SENSENICH PROPELLER CO., INC.

SERVICE BULLETIN SB2016-06A
(Supersedes SB2016-06)

SUBJECT: Inspection of adjustable pitch hubs for cracks

Figure 1. Cracks start near pitch marks and grow outwards.

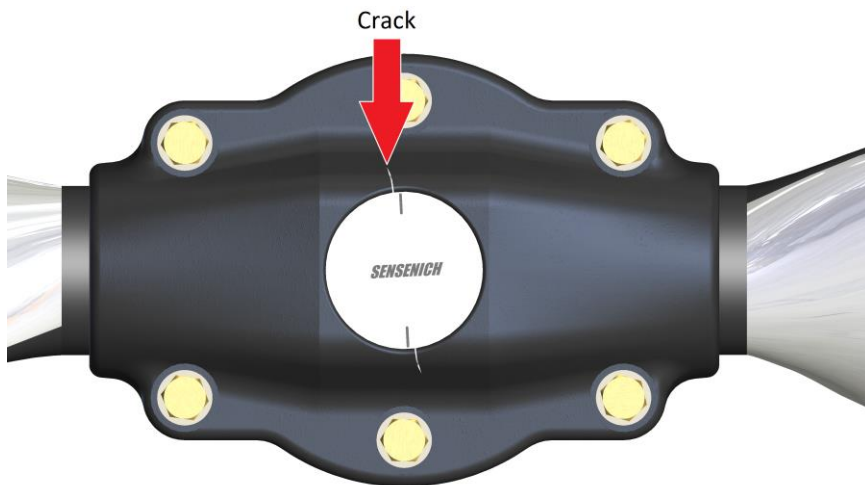
REASON: Sensenich has received reports of cracked hub covers on several tractor and pusher installations with Jabiru engines. A single occurrence on a tractor Rotax was reported in June 2018.

- The occurrence, if unattended, could result in the hub cover half cracking completely across.
- To date, there have been no inflight blade separations but the location of crack growth necessitates immediate inspection.

- Inspect hub for cracks before next flight.
- Remove spinner dome (and front bulkhead, if used). Closely inspect the hub cover (clamp half) around the pitch cylinder and on the hub sides. Also examine the sides of the hub mount half. See Figures 1 and 2.
- Notify Sensenich of any crack occurrences and return hub for evaluation.
- Inspect hub for cracks every 50 hours or annually.
